Letters

Correction to "Field Theory Design of Rectangular Waveguide Broad-Wall Metal-Insert Slot Couplers for Millimeter-Wave Applications"

Fig. 1. Figure of Table I with correct designation of the slot lengths.

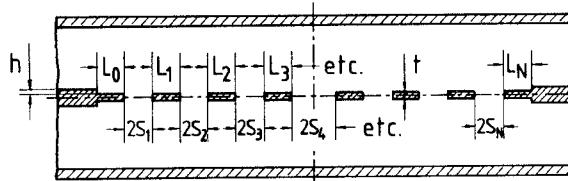
In the above paper,¹ the designation of the columns "Slot Lengths (mm)" of Tables I-IV should have read "Half Slot Lengths (mm)," as is indicated correctly in Fig. 1 of the paper, by

$z = l_1$, $z = 2l_1$, respectively, for the first slot. S_1, S_2, \dots , in the figure of Table I, therefore, should have read $2S_1, 2S_2, \dots$, as shown above.
